## Memorandum

Date: June 26, 2012  
To: West Linn Planning Commission  
From: Peter Spir, Associate Planner  
Subject: Chase Bank (DR-12-08)

Date: June 21, 2012  
To: West Linn Planning Commission  
From: Khoi Le, Public Improvement Program Manager  
Subject: Chase Bank (DR-12-08)

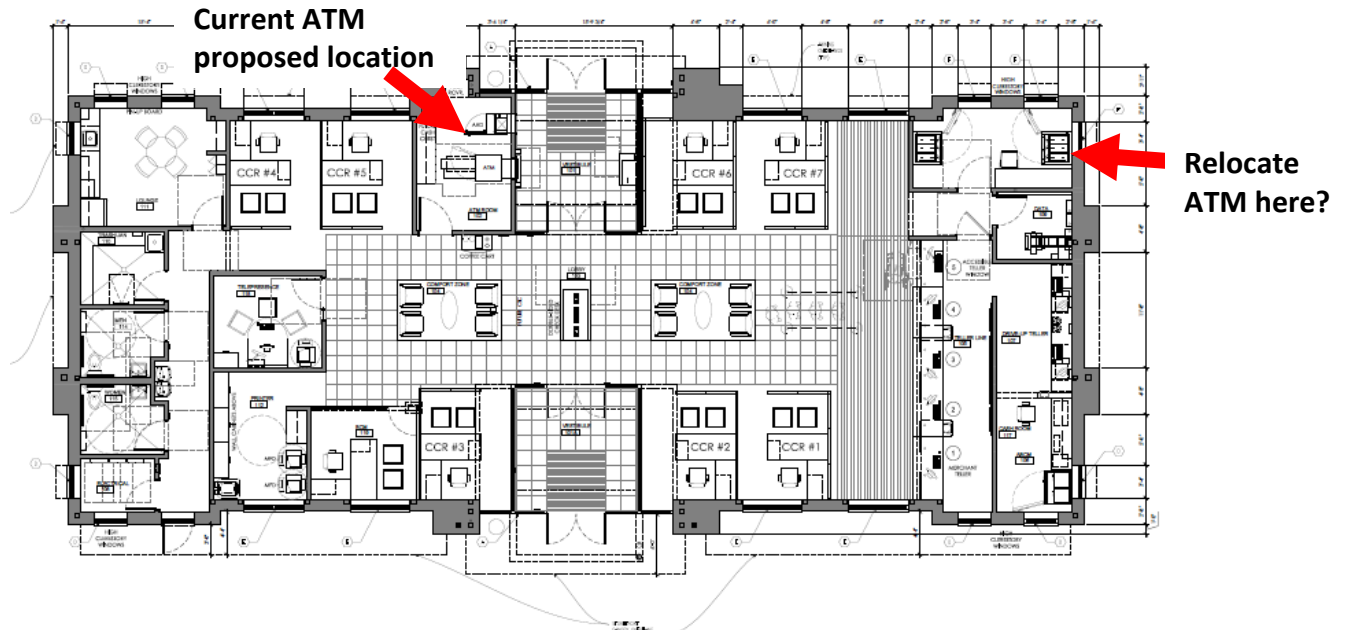
Security and surveillance of the ATM machine and vestibule at the rear elevation of the bank was a concern raised by Commissioner Steel. Commissioner Steel proposed a number of

options including moving the ATM to the front or side of the bank. The applicant prefers the rear location since it is accessible and convenient to customers who park at the rear of the building.

During daylight/business hours, the issue of surveillance is not as acute since the area will be observed by bank employees. During non-daylight/non-business hours, surveillance becomes more of an issue. Compared to potential surveillance of the front elevation at night time, which can be seen by passing motorists, surveillance of the rear elevation is comparatively limited. Surveillance is limited to lines of sight from adjacent commercial properties, such as the late night 7-11 business that generates a significant amount of nighttime traffic. Other ATM customers waiting to use the ATM would also offer surveillance.

Relocating the ATM to the side of the building has some advantages in terms of improved visibility or surveillance potential and the 25-50 foot distance from the parking lot to an ATM at the southeast corner of the bank would not be unreasonable. The downside is that it would require significant redesign of the bank's interior.

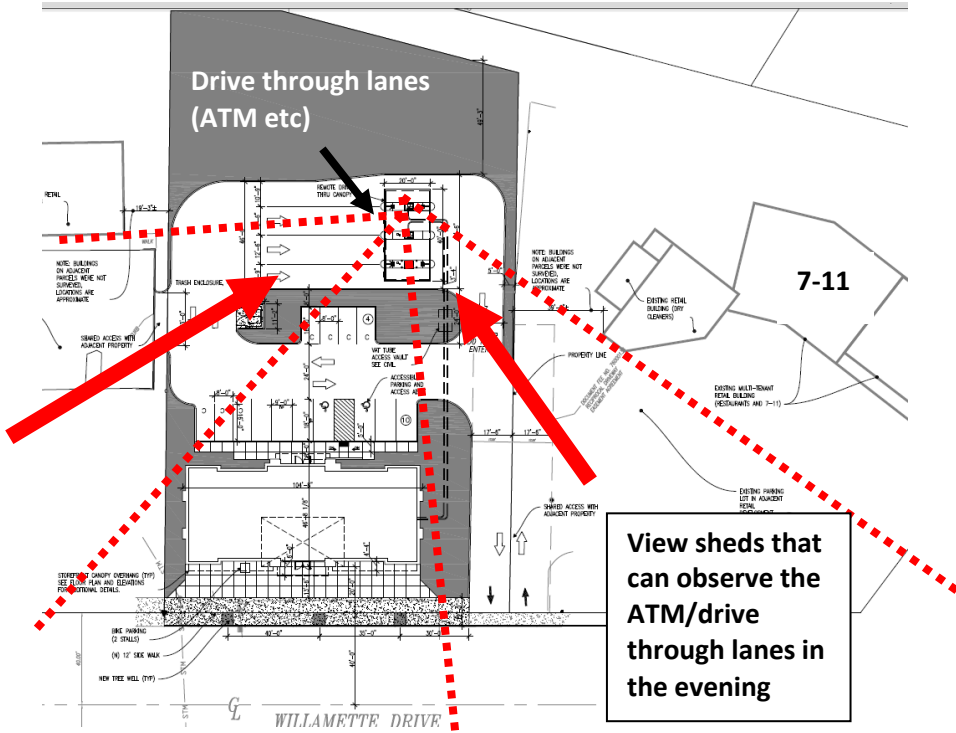
Security and surveillance of the drive through ATM machine at the rear of the bank was a concern raised by Commissioners Miller and Holmes. The concern was that there should be good lines of sight of the ATM, particularly since there is a landscaped area east of the drive through area that could harbor thieves.

Surveillance of this area is better than the ATM in the bank as shown on page 20 (finding 8) of the staff report. In addition to views from the 7-11 parking lot, the site will be visible to north bound traffic on Willamette Drive as well as southbound traffic along with customers of Willamette Village to the north. The connecting driveways will facilitate security drive throughs by police.

Security is enhanced by a lighting system and the installation of a six foot cyclone fence on the east and side lot lines.

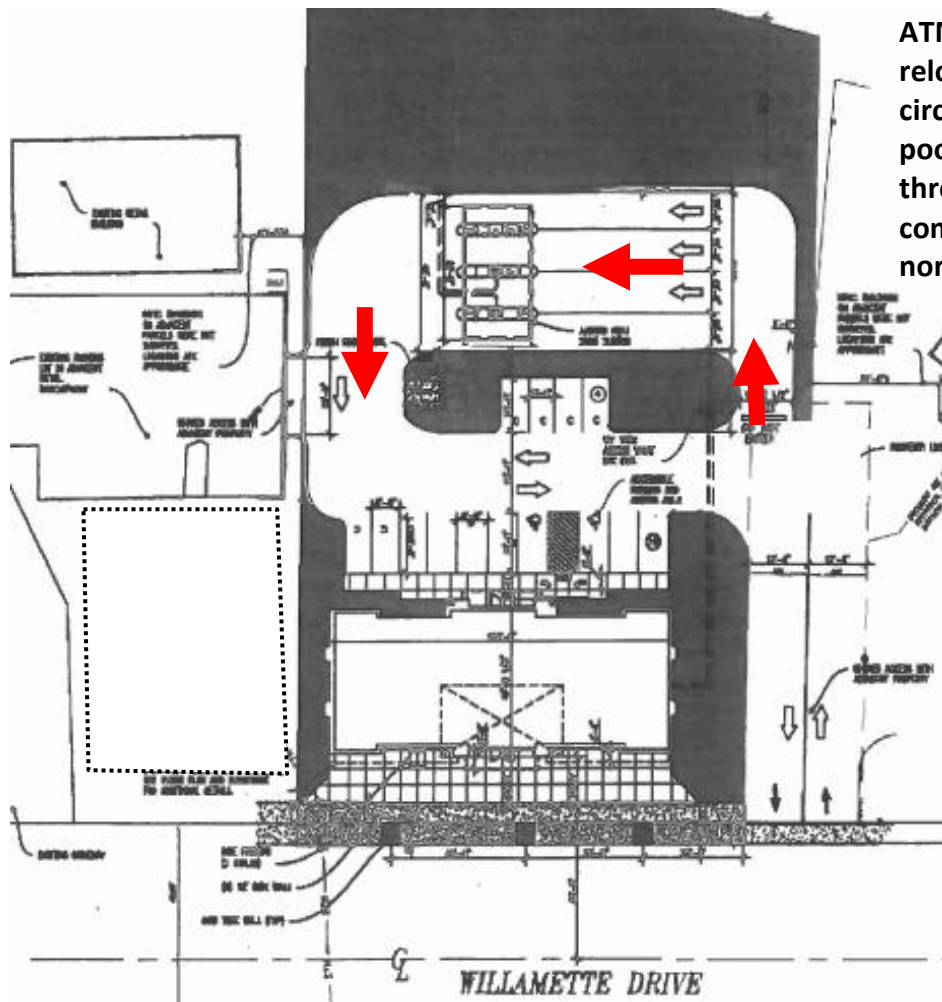
On-site vehicular circulation and consideration of other driveway locations was an issue raised by Commissioner Steel. The thought was that other driveway configurations might better facilitate a new ATM location that could be better observed.

Other internal circulation patterns, such as reversing the direction that vehicle would approach the drive through ATM and VAT stations, were not seen as producing any significant advantages. For example, the reverse flow would place the drive through ATM in a location that would not be as easily observed as the current proposal.

ATM drive through relocated to reverse the circulation plan produces poor surveillance of drive through especially when commercial pad to the north is developed.
